# BAYSIDE COUNCIL

## Planning Assessment Report

| <b>Application Number:</b> | DA-2020/12                                                                                                                                                                                                                                                                                                                                       |
| <b>Proposal:</b>           | 17, 19, 21-25, 29, 31, 33 & 35 King Street, ROCKDALE NSW 2216 -<br>Integrated Development - Demolition of existing buildings and<br>construction of an eleven (11) storey mixed use development consisting<br>of 133 apartments, six (6) commercial tenancies and basement car<br>parking with access via Crofts Lane                            |

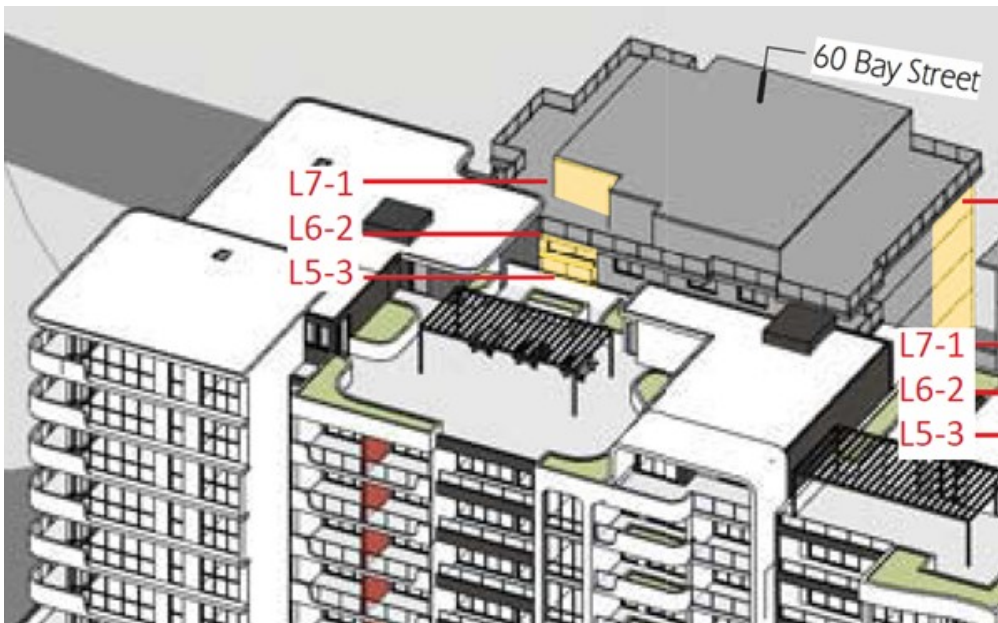
Comment: The apartment building at No.60 Bay Street currently receives 42% solar access (i.e. - 8 out of 19 apartments get the required 2 hours). This would be reduced to 15% (i.e. - 3 out of 19 apartments). The loss of solar access is greater than 20% and therefore does not satisfy the ADG guidelines. There would be some apartments which go from 6 hours solar access to no solar access in mid-winter. The ADG requirements anticipate increased building separation (i.e. - beyond minimums) where the proposal will significantly reduce the solar access of neighbours. For the most part, the proposal does not provide this.

**Extract of 12pm solar access - proposed. L5-3 is on the 3rd level from the top and does not receive solar access**

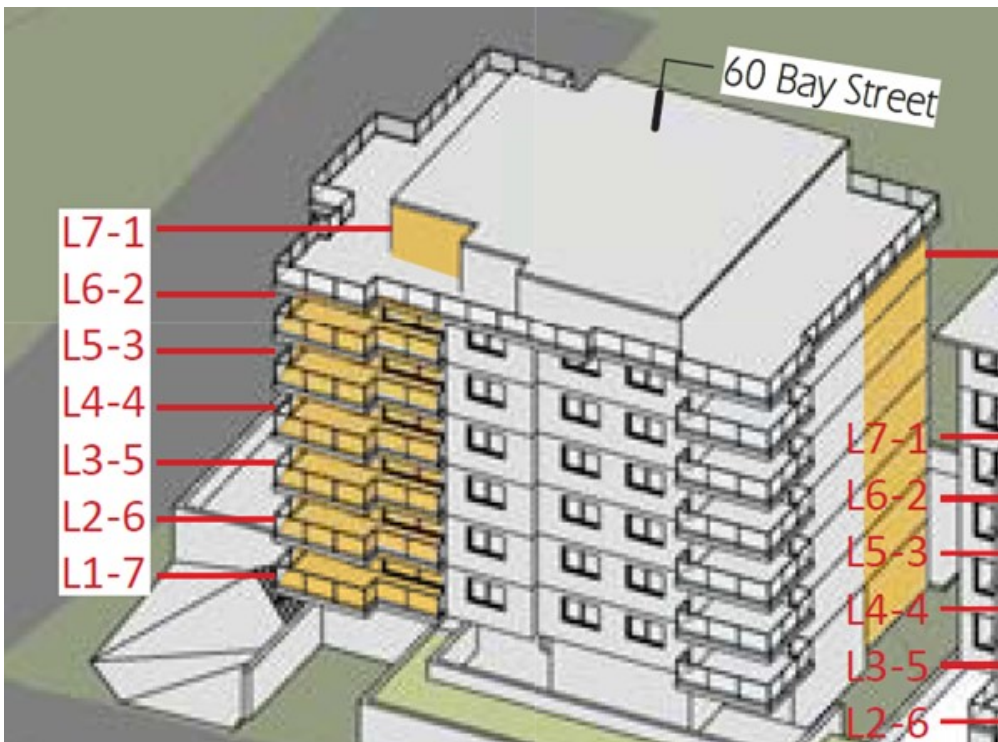
It is noted that the solar access diagrams count the L5 - 3 apartment as receiving solar access. However, it is evident that the balcony and windows to main internal living areas of this apartment would not receive the required sunlight and therefore are unable to be counted.

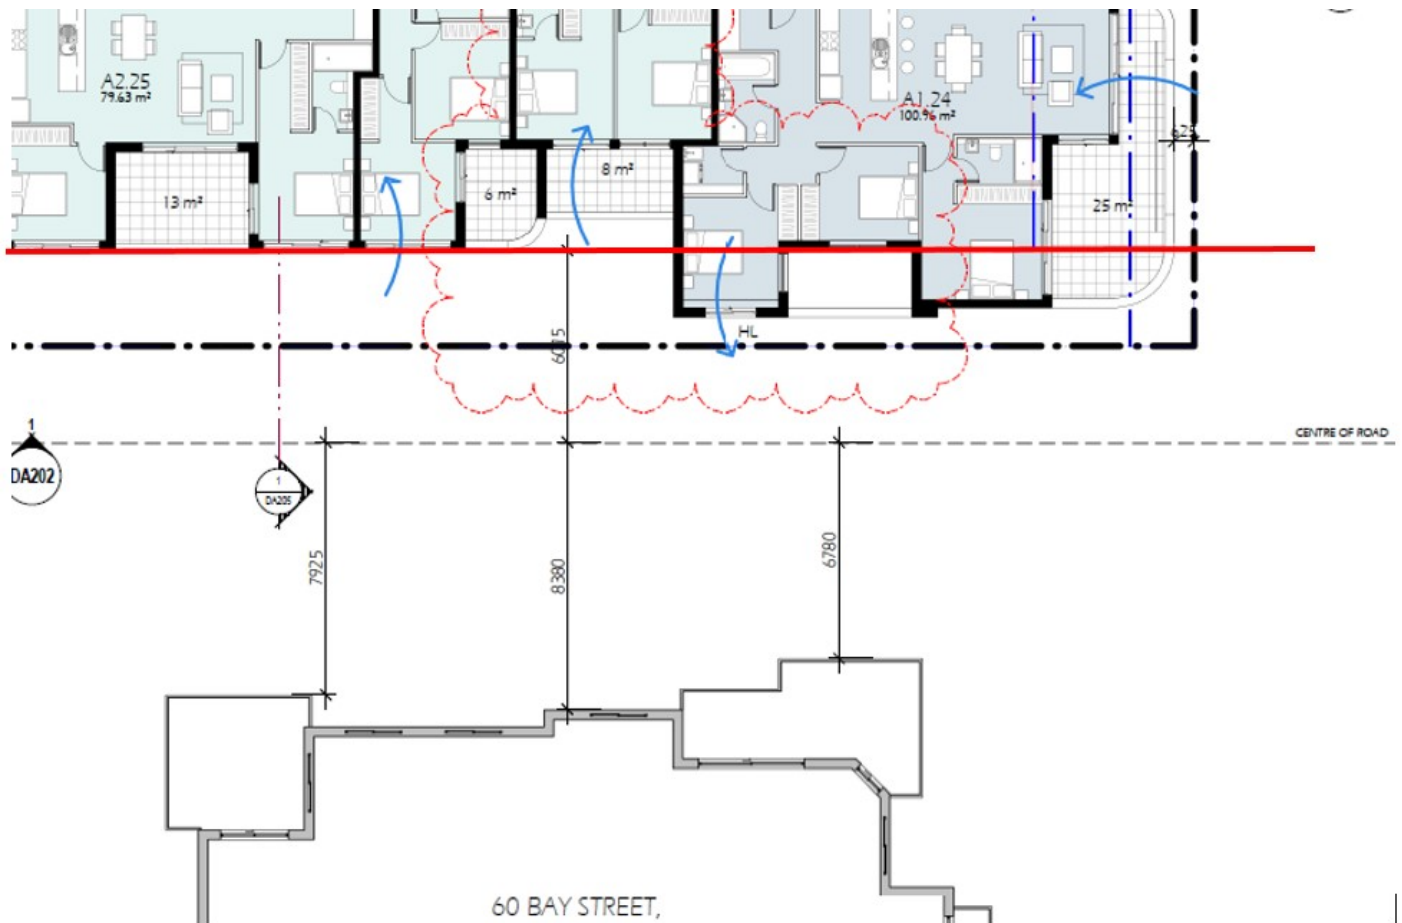
The design of the development includes open plan layouts where the maximum habitable room depth is greater than 8m from a window. Greater than minimum ceiling heights can allow for proportional increases in room depth up to the permitted maximum depths, however, the ceiling heights proposed are on minimums.

There are residual areas within some apartments with no identified uses. For example- B2.13, B2.23 etc and A2.12, A2.22 etc.

### 7.5.2 Local Edge George Street

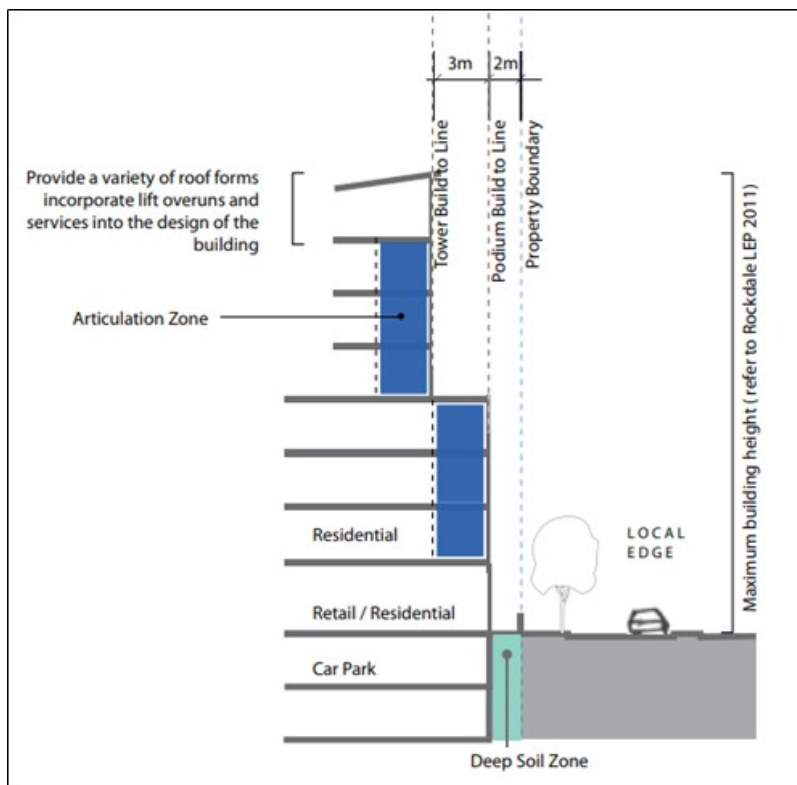
The George Street frontage to the east is identified as "Local Edge". The DCP controls specify the following requirements:

Comment: The design of the development is inconsistent with the setback requirements identified above. The design of the building does not align with the stated DCP outcome to *transition from the strong urban character in the Centre core to the more spacious and open character of the surrounding residential area*, noting that the opposite (eastern) side of George Street is the R2 Low density residential area.

The diagram below is an extract of the proposed 5th storey and shows lines which identify the rear 9m separation (ADG) and required DCP setbacks (5m to George Street - including balconies).

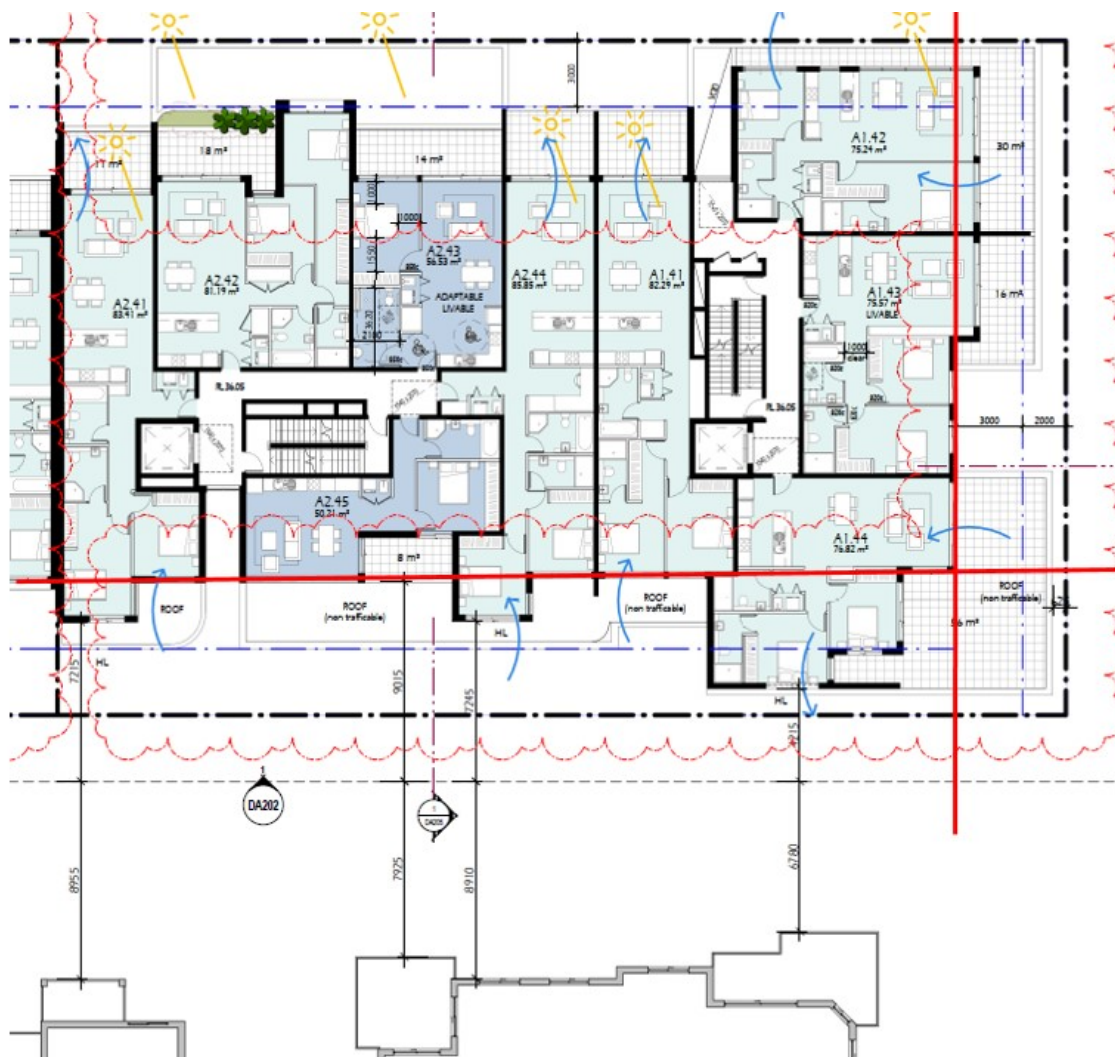
It is noted that the amended plans show the required 2m deep soil zone to George Street. However, it is overhung by the building above (part of which is 625mm off the eastern George Street boundary) which is inconsistent with the DCP setback and massing requirements.
